# CITY PLANNING COMMISSION

**APPLICATION:** A. Special Permit to develop a parking lot in the Single Family (R-1) and General Commercial (C-2) zones (Section 2-C-31)  
B. Lot Line Adjustment to merge five lots

**LOCATION:** Northeast corner of 33rd Street and Folsom Boulevard (3301 to 3319 Folsom Boulevard, 1435 33rd Street and 1434 34th Street)

**PROPOSAL:** The applicant is requesting the necessary entitlements to develop a 15 space parking lot on a portion of 0.5+ acres for an existing office and a proposed restaurant use.

SITE PLAN  
1" = 15'

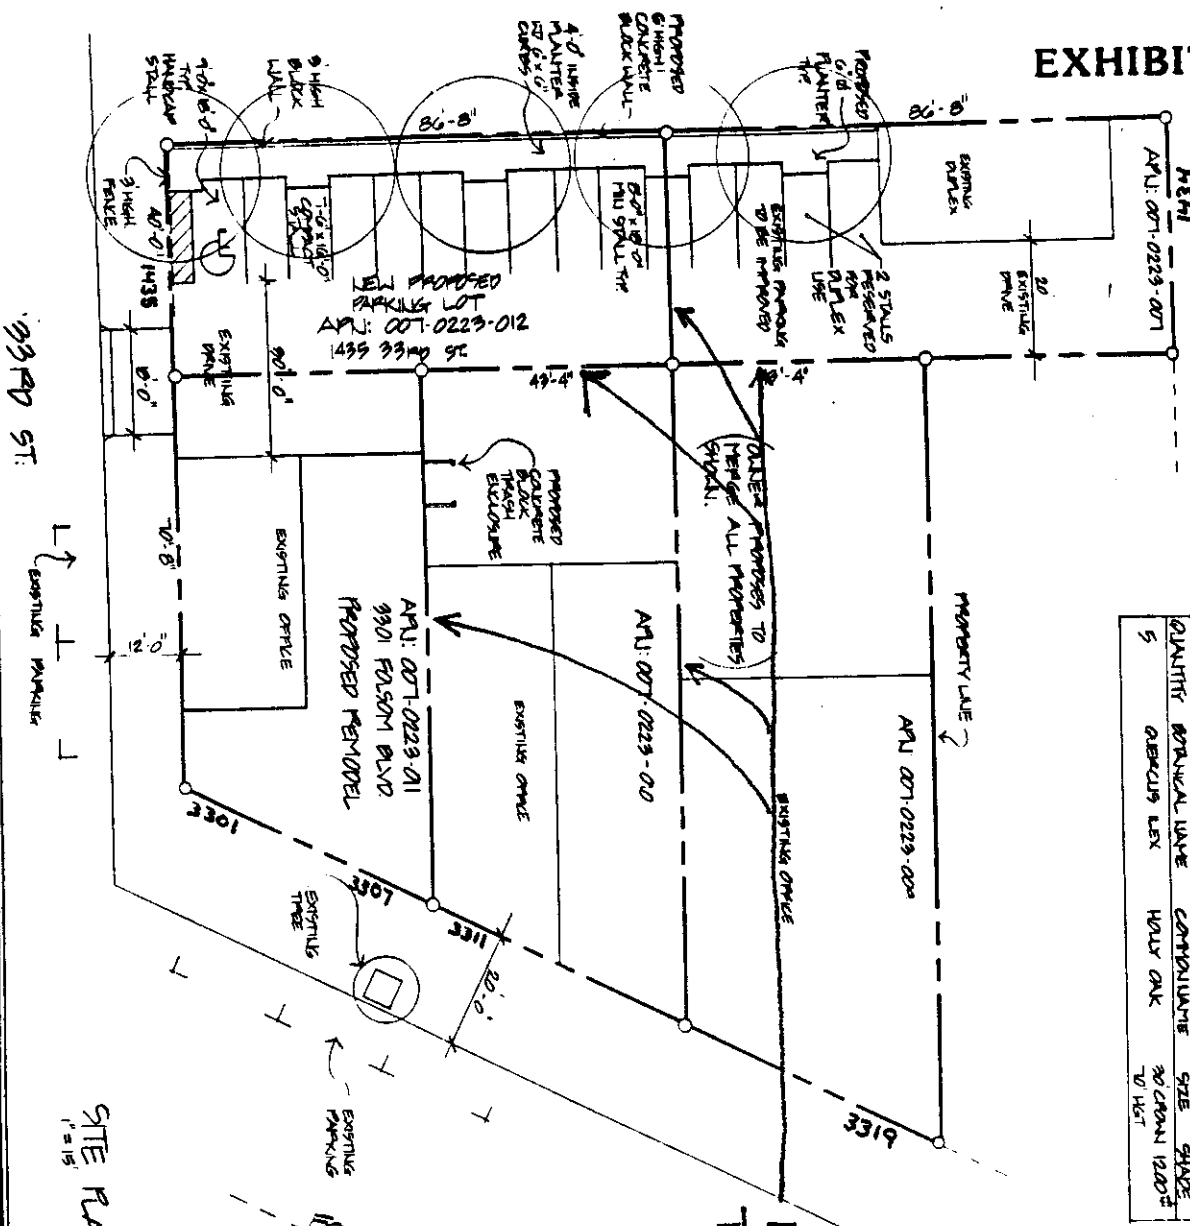
The submitted site plan indicates 15 parking spaces. The proposed parking lot plan has been reviewed by the City Planning, Building and Traffic Engineering Divisions. The following site plan modifications are recommended prior to issuance of building permits:

1. Show the required four-foot-wide planter adjacent to the 33rd Street right-of-way.
2. Eliminate two to three parking spaces and increase planter width to seven feet along the north property line in order to meet 50 percent shading requirement.
3. Indicate existing utility pole in driveway. The pole cannot interfere with parking stall maneuvering. If it does, the pole must be relocated.
4. Indicate existing driveways and existing paving on revised site plan. Driveway entrances are to meet required widths of City Traffic Engineering Division.
5. Existing striped parking on the eastern commercial site shall be indicated on the revised site plan.

1. A revised parking lot site plan shall be submitted for staff review and approval prior to issuance of building permits. The revised site plan shall be drawn to a scale acceptable to the City Building Division and shall indicate the following modifications:

- a. The required minimum four-foot-wide planter with six inch concrete curb (minimum five feet wide, total) adjacent to the 33rd Street right-of-way;

- b. Revised landscape, shading and irrigation plans which meet the City's 50 percent shading requirement and utilize a two-foot planter overhang by parked vehicles;

- c. The existing utility pole in the driveway. The pole cannot interfere with parking stall maneuvering. If it does, the pole must be relocated;
  - d. Existing driveways, existing paving, existing porches, existing walkways and any existing striped parking proposed to remain on the revised site plan. The driveway entrance is to meet required width of the Traffic Engineering Division;

STAFF EXHIBIT  
(Not to scale)

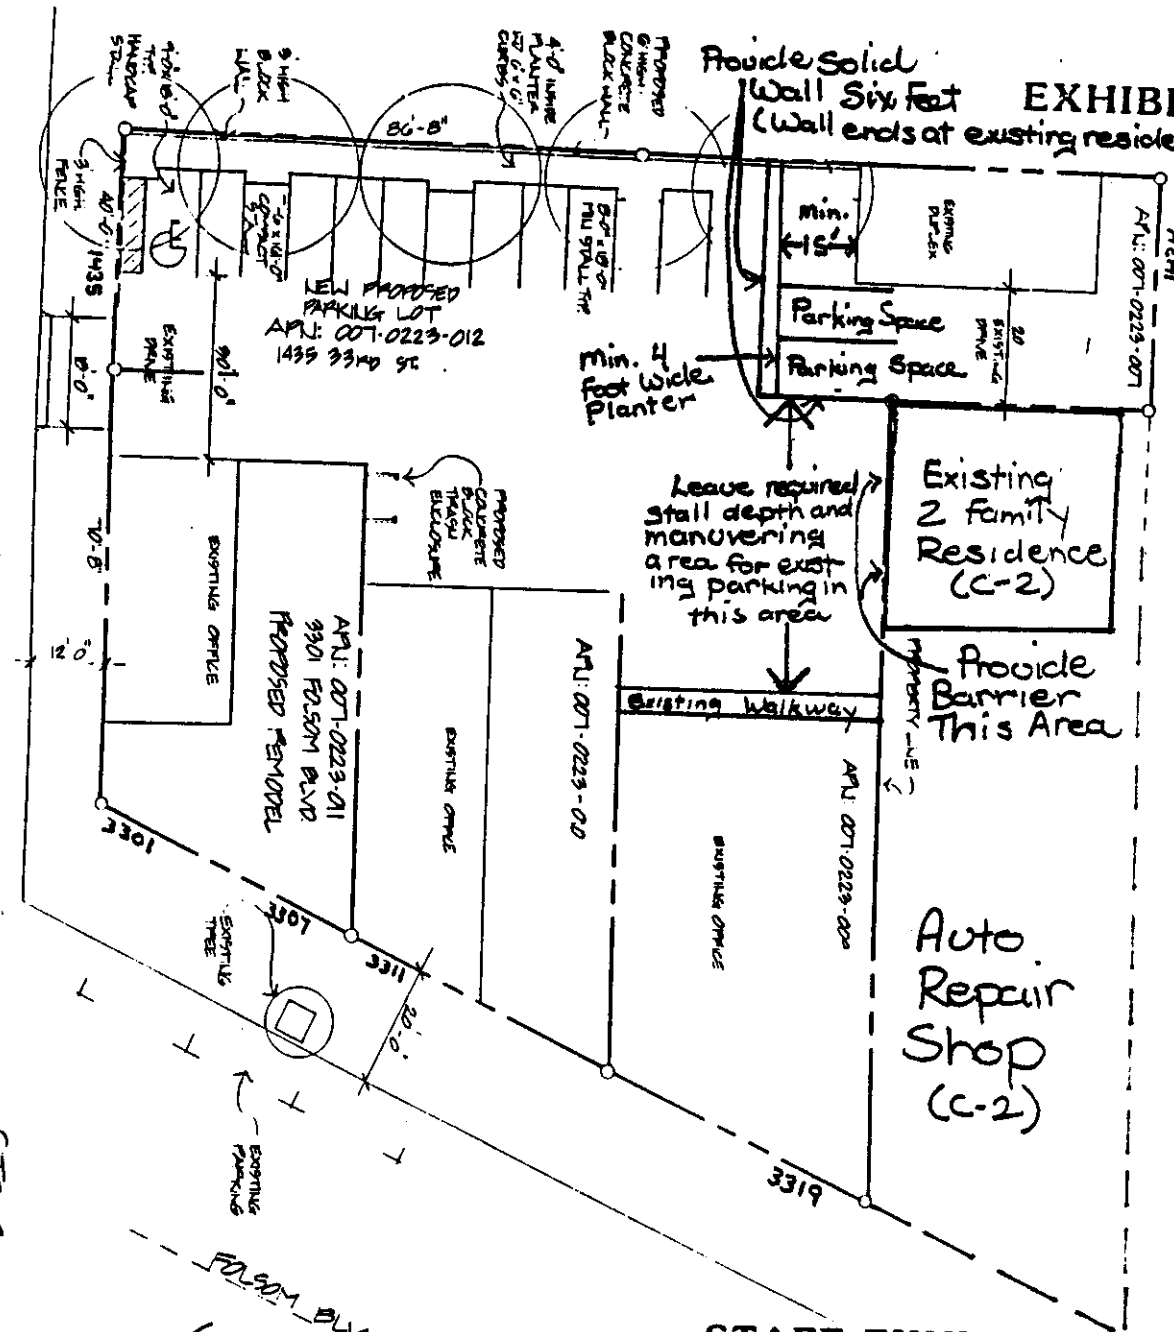
- e. Minimum four foot wide planter adjacent to duplex use as indicated by Exhibit F; and
  - f. Trash enclosure location(s).
2. A six-foot-high solid wall (three feet in front setback area adjacent to 33rd Street) shall be located adjacent to the northern property line and surround the existing duplex as indicated by Exhibit F. Design and materials of the wall shall be subject to Planning Director review and approval prior to issuance of building permits.

4. The applicant shall provide a parking barrier to protect the existing residence on the adjacent C-2 zoned property from vehicles parking on the adjacent site (see Exhibit F). The type of barrier shall be reviewed and approved by the Planning Director prior to issuance of building permits.
